Public (897) Department.

G.O., No. 526

DATED 7-5-97

TYPE DESIGN FOR CHOLERA HOSPITAL

STANDARD PLAN OF DISPENSARY FOR
WOMEN AND CHILDREN
APOTHECARY'S QUARTERS

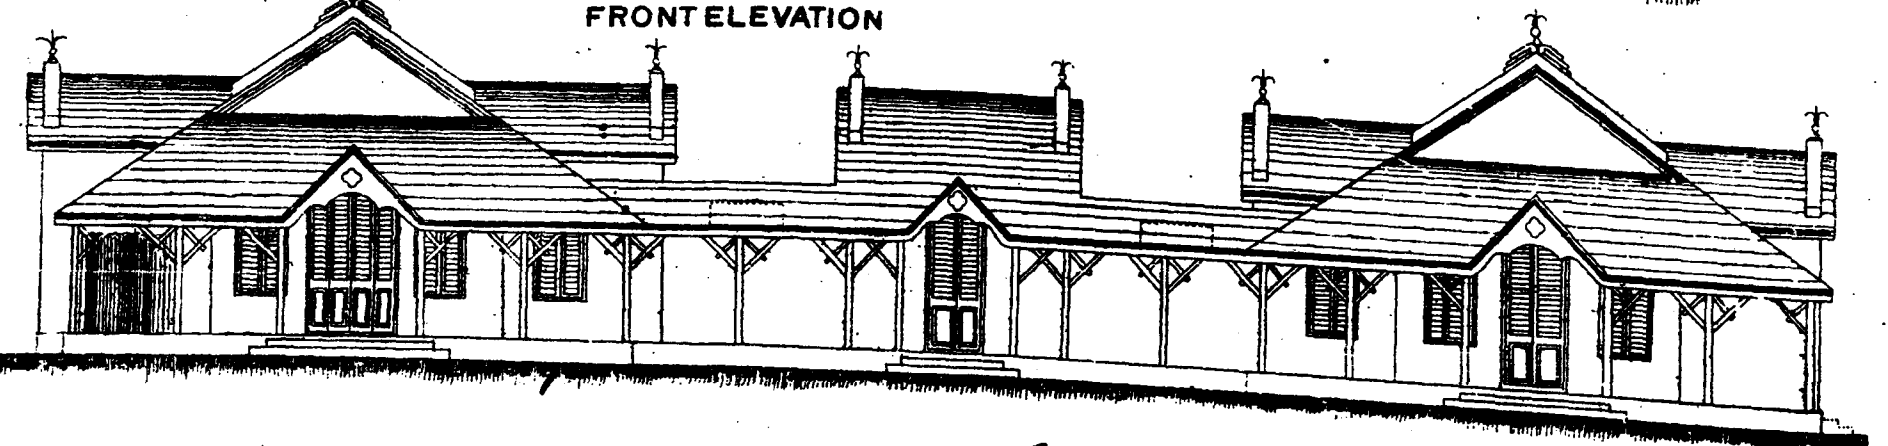
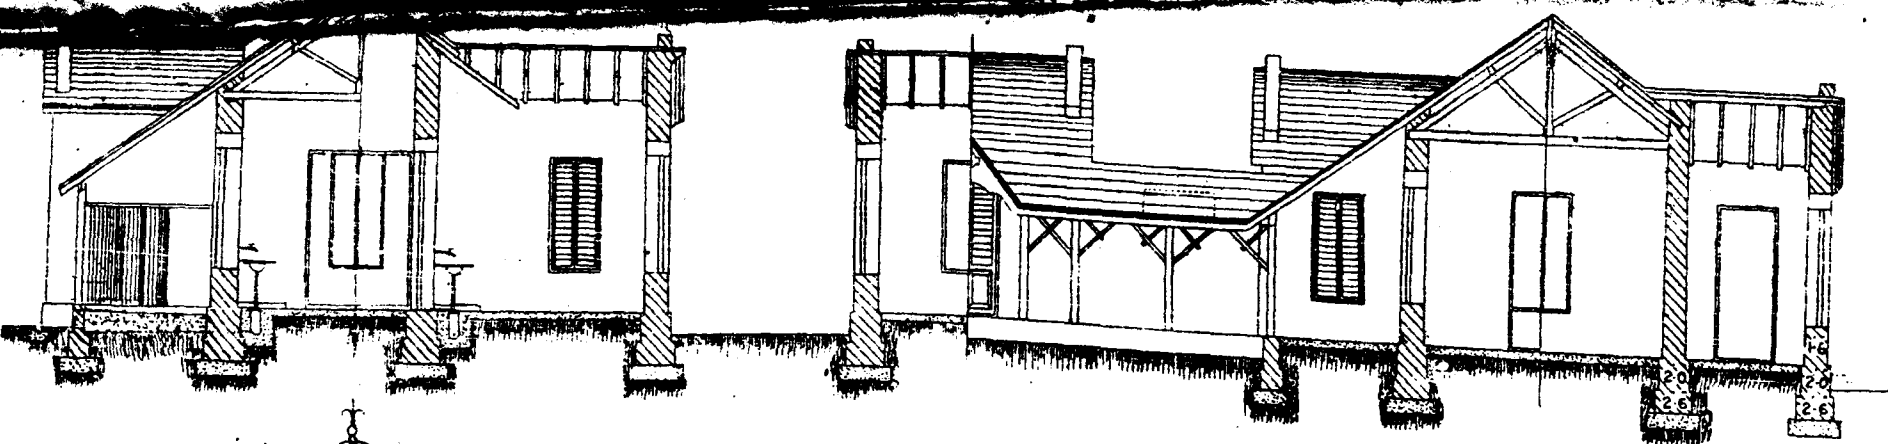
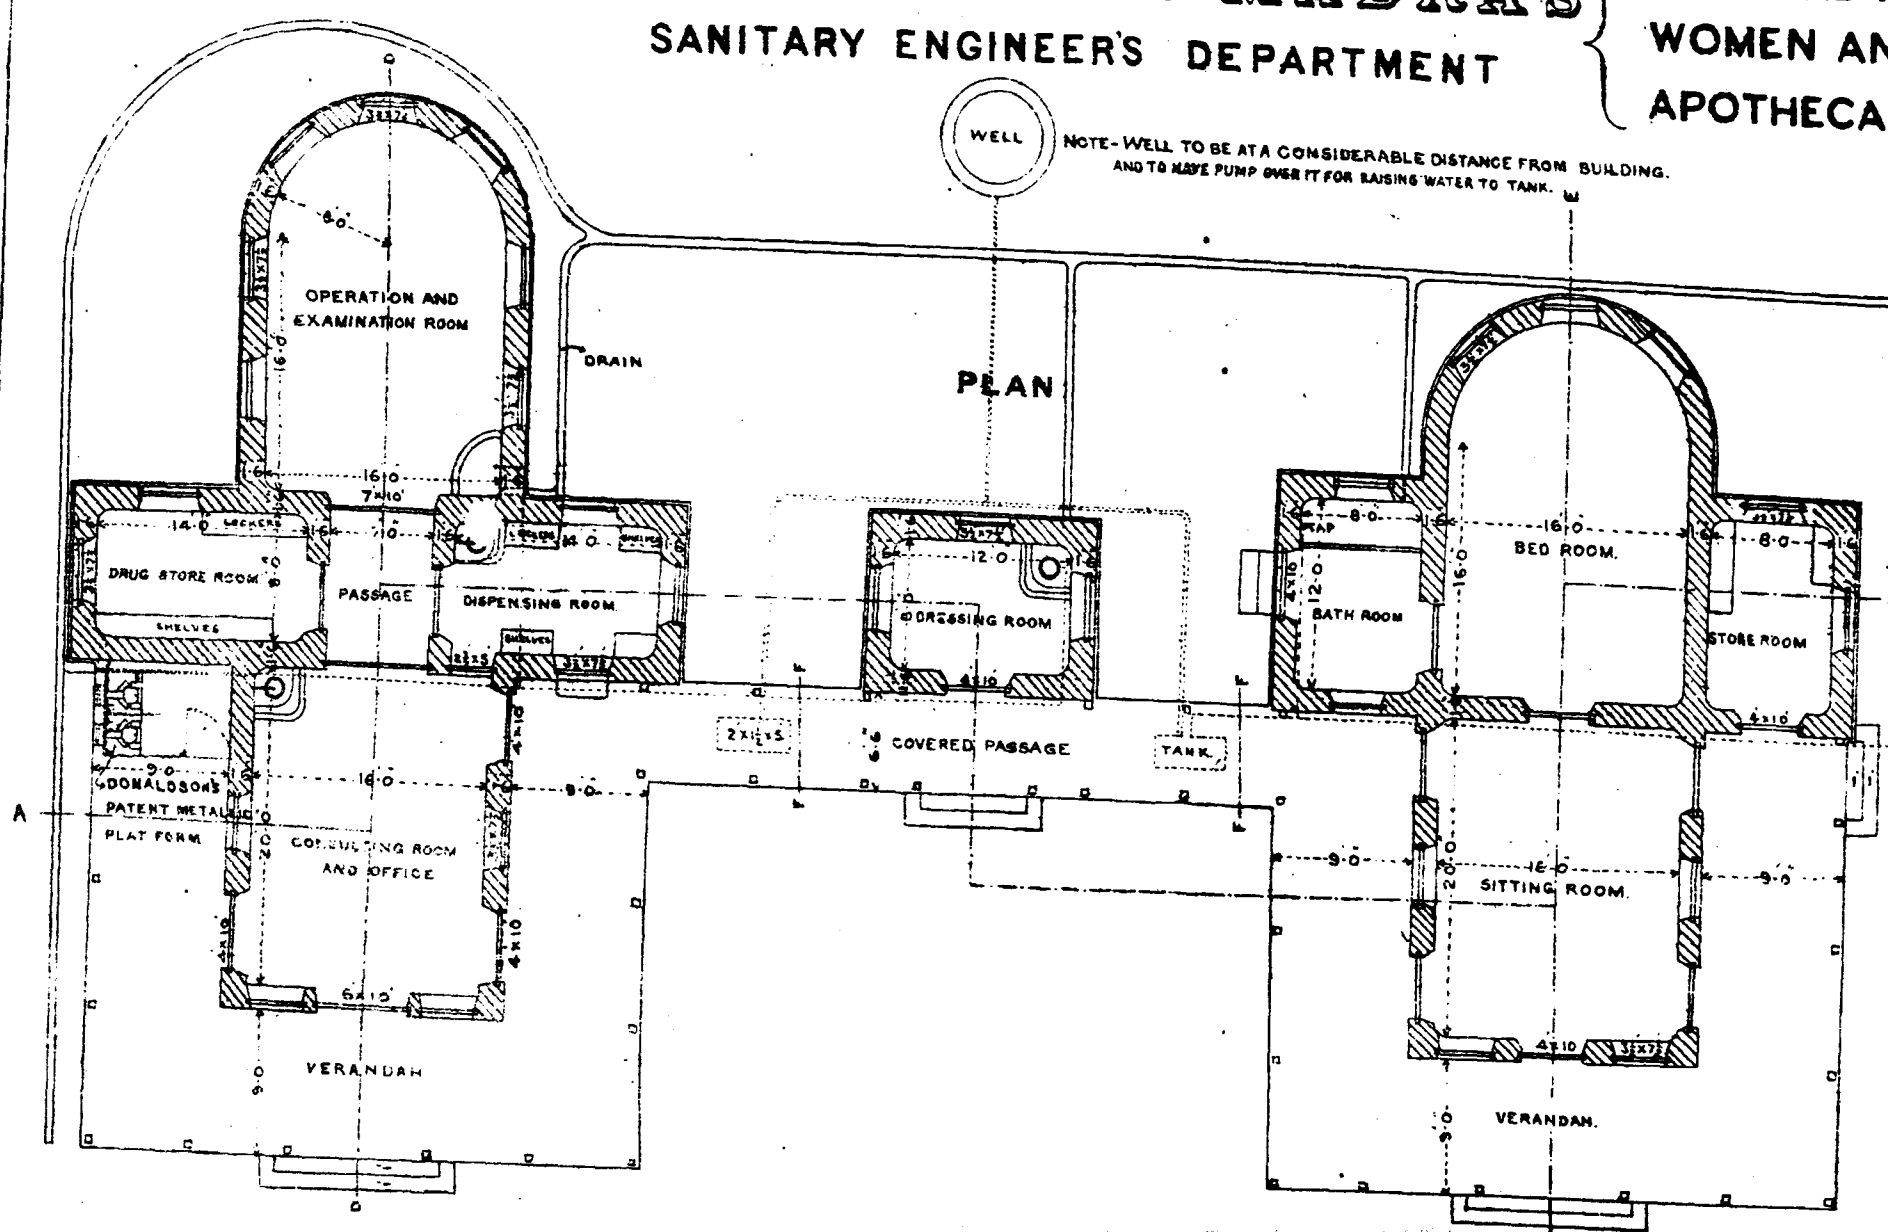
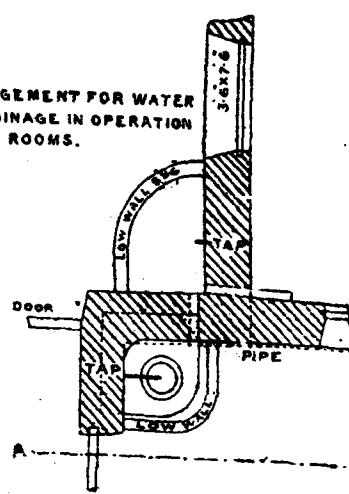
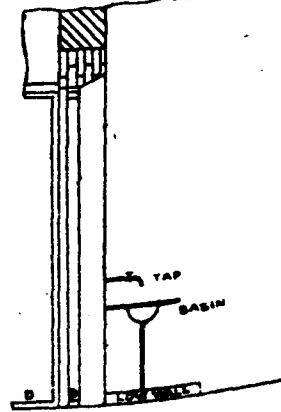
The Surgeon-General in the ^{encloses a plan} current ^{it} states that in ~~the standard plan which he encloses~~ there are two dressing rooms: that plan is however not one "sanctioned by the Sanitary Board," (the description of the "standard plan" given by the Surgeon-General in his letter No. 98, dated 26th February 1897) but merely one prepared by the Sanitary Engineer. The Surgeon-General's wrong description of the plan to which he referred has thus given rise to the present confusion.

As for the dressing room the Surgeon-General insists that separate dressing rooms for males and females are necessary and prefers to ~~the~~ so-called "standard" plan prepared by the Sanitary Engineer. That plan contains two dressing rooms, but it is intended for a far larger institution than that at Polavaram: it devotes one side of the building to males and the other to females.

It is submitted that in a small dispensary arrangements can easily be made for ^{treating at a separate hour} ~~visiting~~ ~~visiting~~ ~~visiting~~ the few females who present themselves, and that no reconsideration

ed for The foot does not, for financial reasons, feel justified in reconsidering G.O. No. 278 Subdy 16.3.97. In a small dispensary such as that required at Polavarani arrangements could easily be made for treating at a separate hour the few females who may present themselves.

2. The use of the term "standard plan" as applied to any design which has not received the sanction of foot is objectionable and should be avoided.
